Structural RAIs**RAI 3-1:**

Figure RAI 8-6-1
Reduction factors for modulus of elasticity at elevated temperatures

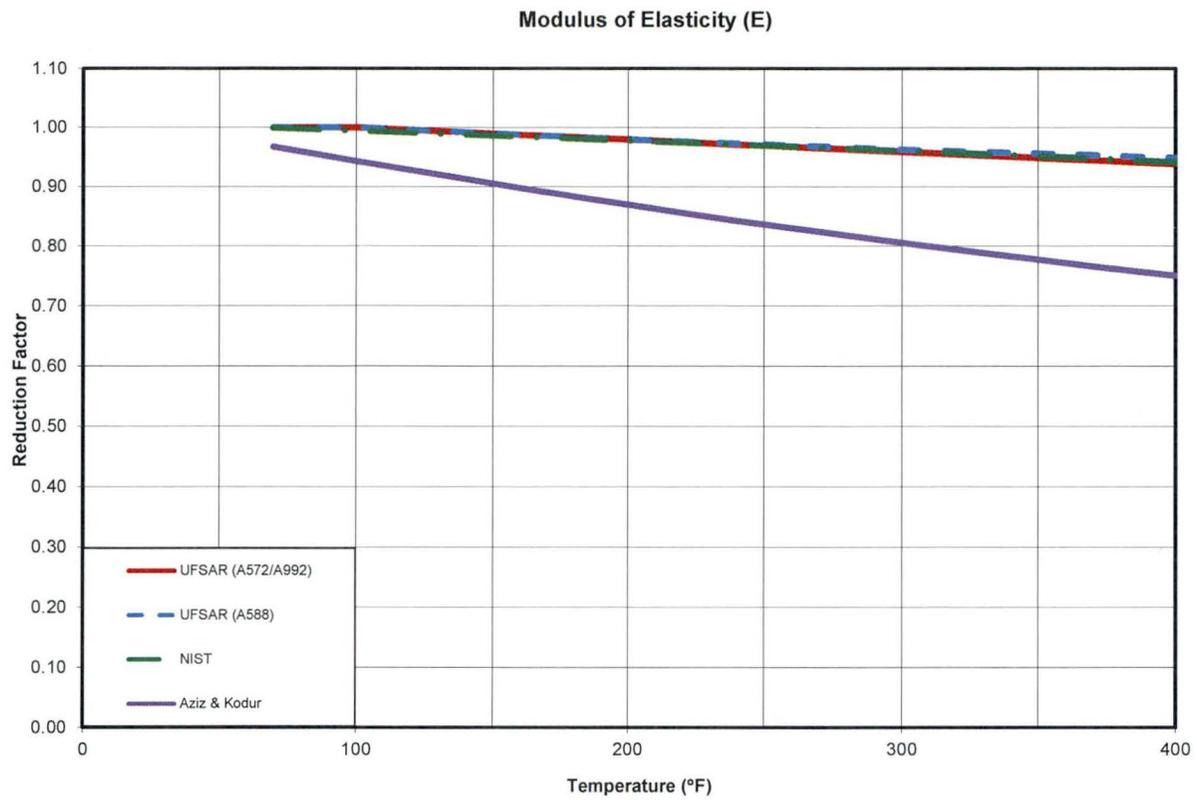
Provide the following additional information for UFSAR Tables A.8-2, A.8-3 and A.8-4 which apply to ASTM A572 Grade 50, ASTM A992 Grade 50, and ASTM A588 steels respectively:

2. Provide allowable stress values for these materials as a function of temperature, a technical basis for the determination of the allowable stresses and an analysis showing that the actual stresses do not exceed the allowable stresses.

Figure RAI 8-6-1 shows that the temperature-dependent values of modulus of elasticity used in the UFSAR for A572/A992 and A588 steels are in very good agreement with those from NIST Technical Note 1907 [2], but greater than those from Aziz and Kodur [3] throughout the entire temperature range. Figure RAI 8-6-2 shows that the temperature-dependent values of yield strength used in the UFSAR for A572/A992 and A588 steels are slightly less than those from NIST [2] and Aziz and Kodur [3] for the entire temperature range, with the exception that the UFSAR properties for A588 are slightly greater than those from NIST [2] for a low temperature range (< 120 °F). Figure RAI 8-6-3 shows that the temperature-dependent values of tensile strength used in the UFSAR for A572/A992 and A588 steels are in good agreement with those from NIST [2] and Aziz and Kodur [3] for the entire temperature range.
